Project	<b>IEEE 802.16 Broadband Wireless Access Working Group</b> < <a href="http://ieee802.org/16">http://ieee802.org/16</a> >	
Title	<b>Supplemental material for Tgd comments</b>	
Date Submitted	<b>2004-04-29</b>	
Source(s)	Itzik Kitroser Yossi Segal Yigal Leiba Zion Hadad Runcom Technologies Ltd. 2 Hachoma St. 75655 Rishon Lezion, Israel	Voice: +972-3-9528440 Fax: +972-3-9528805 <a href="mailto:itzikk@runcom.co.il">mailto:itzikk@runcom.co.il</a> <a href="mailto:yossis@runcom.co.il">mailto:yossis@runcom.co.il</a> <a href="mailto:yigall@runcom.co.il">mailto:yigall@runcom.co.il</a> <a href="mailto:zionh@runcom.co.il">mailto:zionh@runcom.co.il</a>
Re:	802.16-REVd Sponsor ballot recirc	
Abstract	This document contains supplemental material for 802.16-REVd sponsor ballot	
Purpose	Adopt suggested changes into P802.16-REVd/D4 draft	
Notice	This document has been prepared to assist IEEE 802.16. It is offered as a basis for discussion and is not binding on the contributing individual(s) or organization(s). The material in this document is subject to change in form and content after further study. The contributor(s) reserve(s) the right to add, amend or withdraw material contained herein.

**Figure 209—Example of the data region which defines the OFDMA allocation**

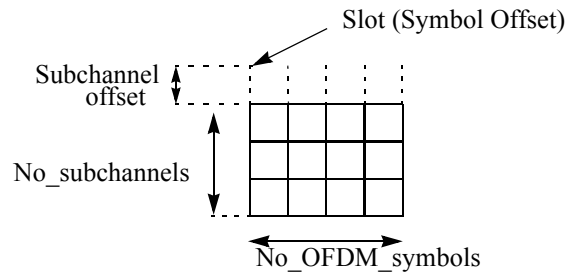
Comment #257. The current OFDMA PHY contain usage of concepts as Zone and a Segment which are not clearly defined anywhere. A clear definition of the terms is required for a consistency reasons. In addition the OFDMA data mapping refers to FEC block, while the correct term is OFDMA slot.

A slot in the OFDMA PHY requires both a time and subchannel dimension for completeness (subchannels are defined in 8.4.6.). An OFDMA slot is one subchannel by ~~two~~one OFDMA symbol.

In OFDMA, a Data Region is a two-dimensional allocation of a group of contiguous subchannels, in a group of contiguous OFDMA symbols. This allocation may be visualized as a rectangle, such as the 4x3 rectangle shown in Figure 209.

Figure 213—Time plan - one TDD time frame (with only mandatory zone)

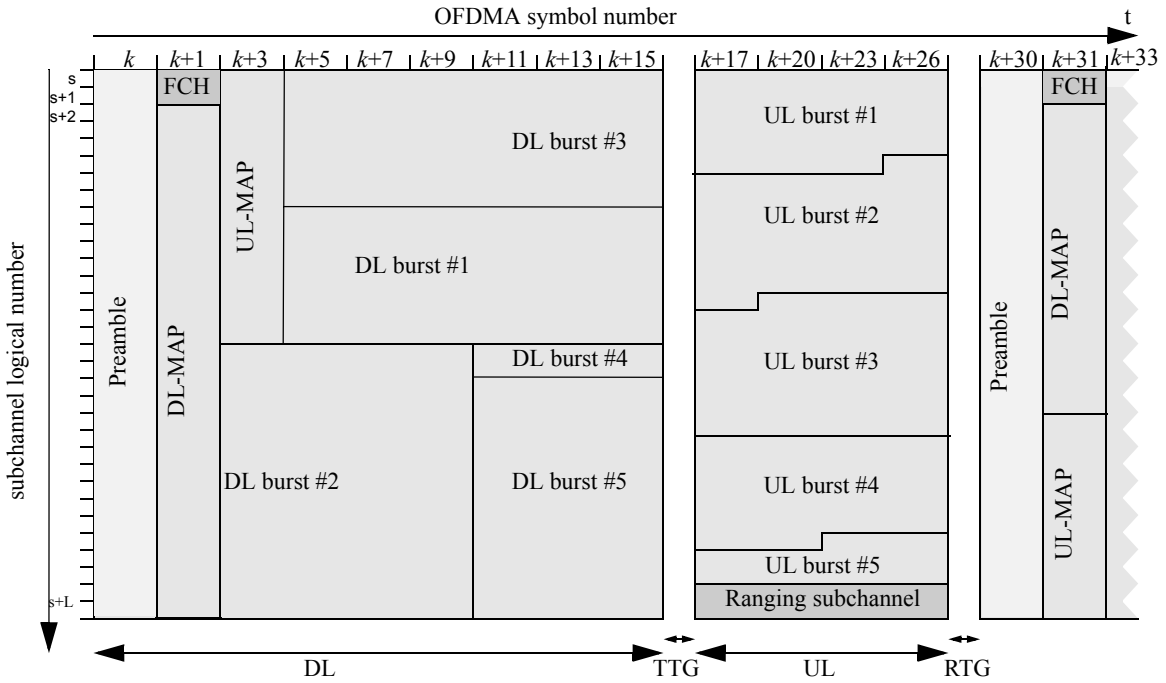
Comment #350 changed the UL allocating scheme to a uni-dimensional scheme. This means that the UL allocations are no longer rectangles, this should be reflected in figure 213. In addition figure 213 does not provide a clear example of the OFDMA frame with multiple zones.

**[Page 468, line 5, section 8.4.4.2, change figure 213 (and title) as follows:]**

**Figure 215—FCH subchannel allocation for all 3 segments**

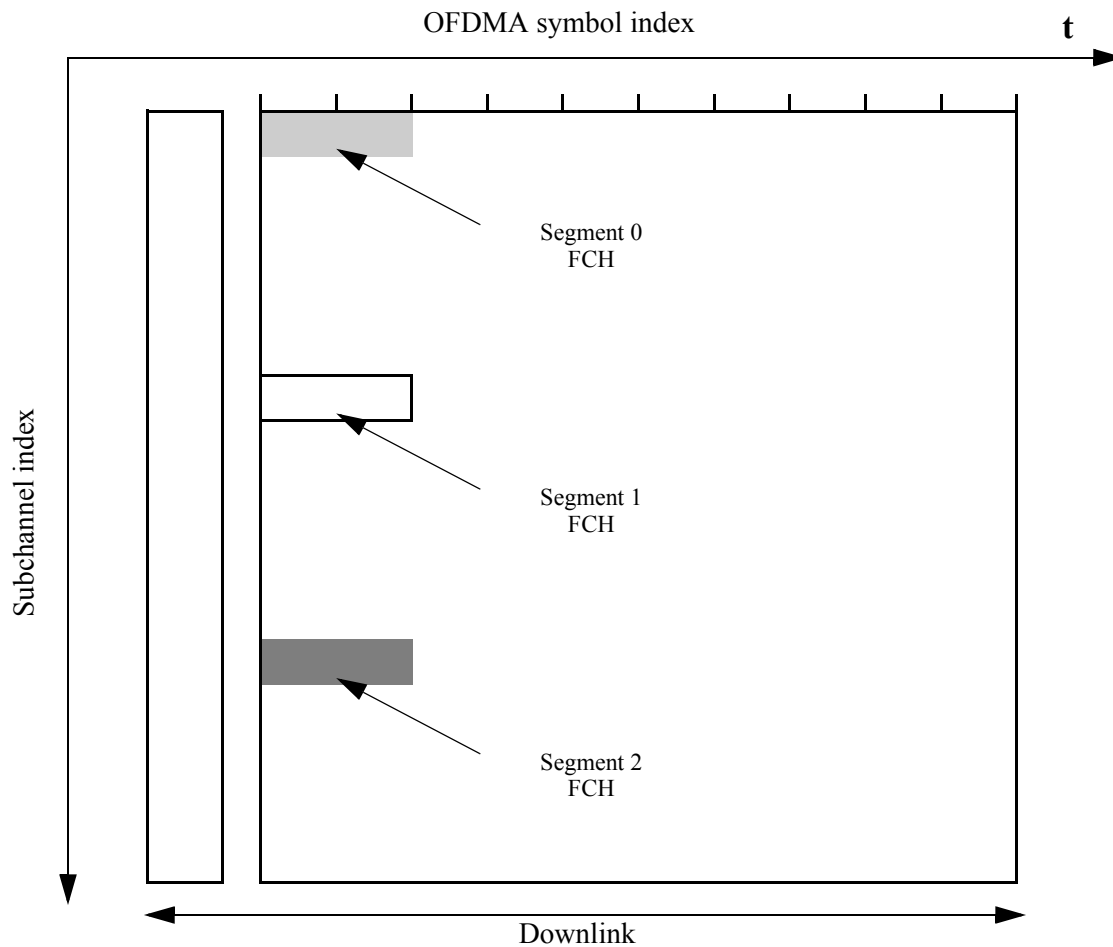
In addition, figure 215 describes the FCH as transmitted over one OFDMA symbol and two subchannels, and should be two OFDMA symbols over one subchannel.

**[Page 471, line 4, section 8.4.4.5, replace figure 215 with the following figure]**

Figure 216—Example of renumbering the allocated subchannels for segment 1 in PUSC

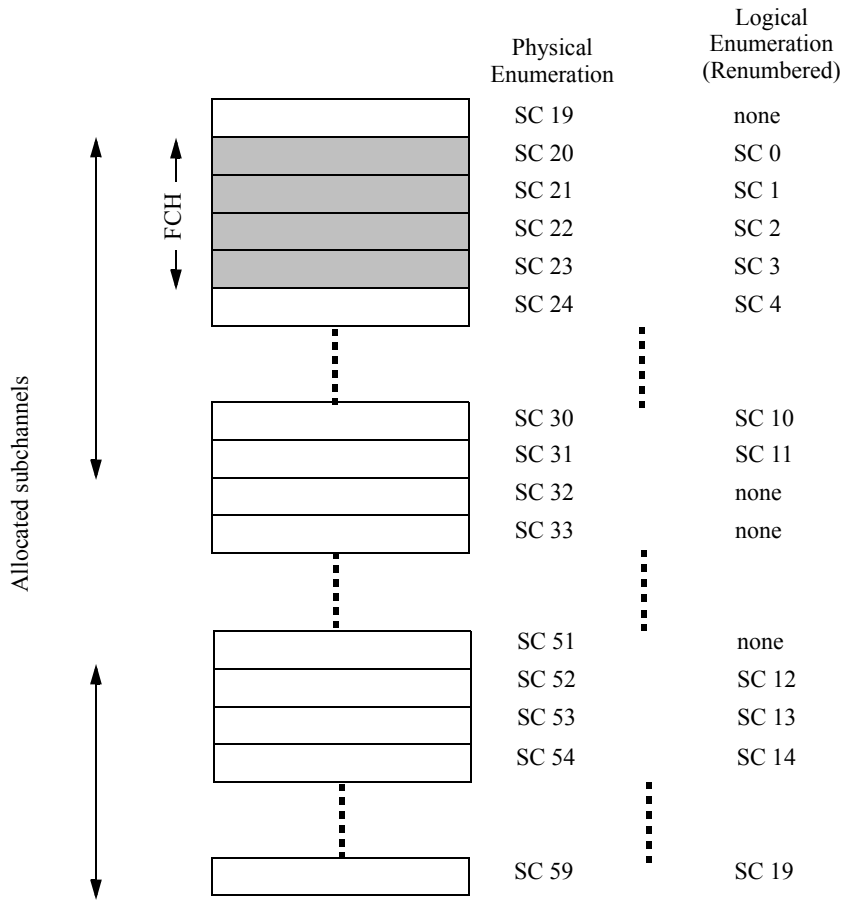
The example given in figure 216 is wrong, since the standard defines that the FCH is transmitted using a duration of 4 OFDMA subchannels.

**[Page 472, line 2, section 8.4.4.5, Change figure 216]**

Figure 217—Example of UL renumbering the allocated subchannels for a segment in PUSC

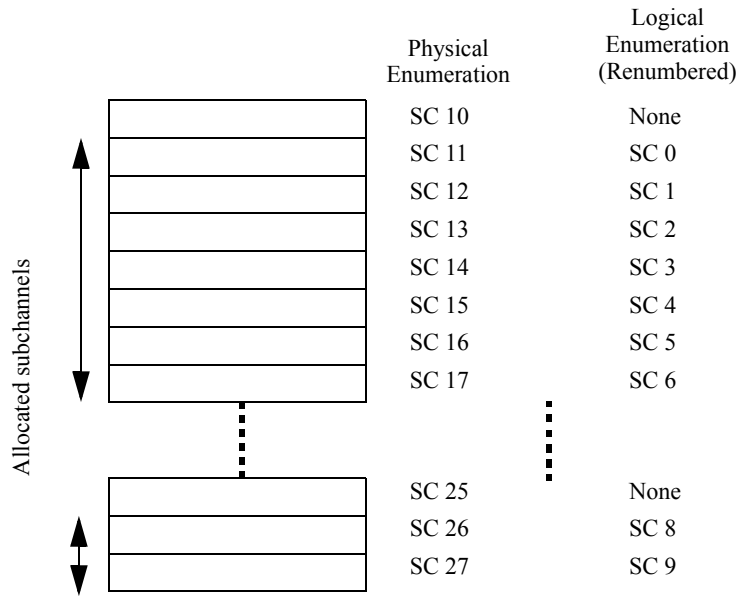
The current subchannels renumbering definition for the UL stating that "no renumbering is done" is wrong, since obviously a renumbering scheme is required.

[Page 472, line 2, section 8.4.4.5, Insert new figure 217]

Figure 235— STC usage with OFDMA for FUSC

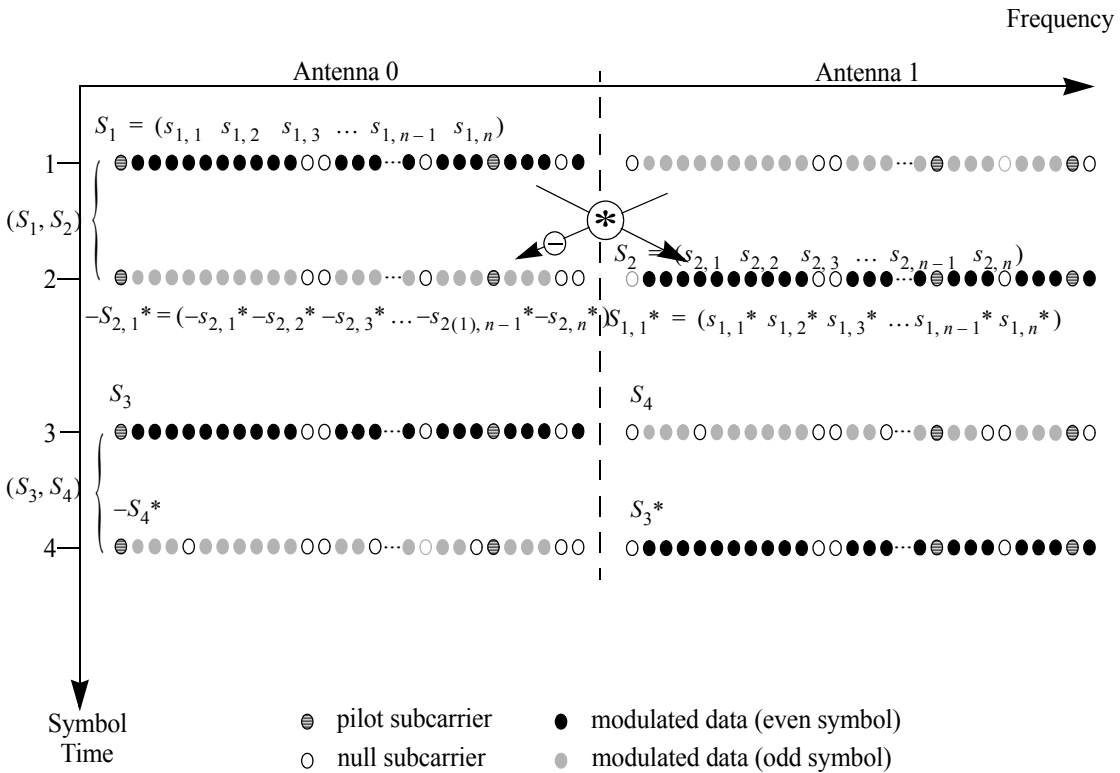
Comment #362 contained instruction to change figure 235, this comment wasn't implemented due to an unclear instruction, this comment provide the required changes. In addition, the existing figure is relevant for FUSC only, an additional figure is required for the PUSC case.

[Page 519, line 3, section 8.4.8.2.1, change figure 235 as indicated, change title to make figure relevant to FUSC]
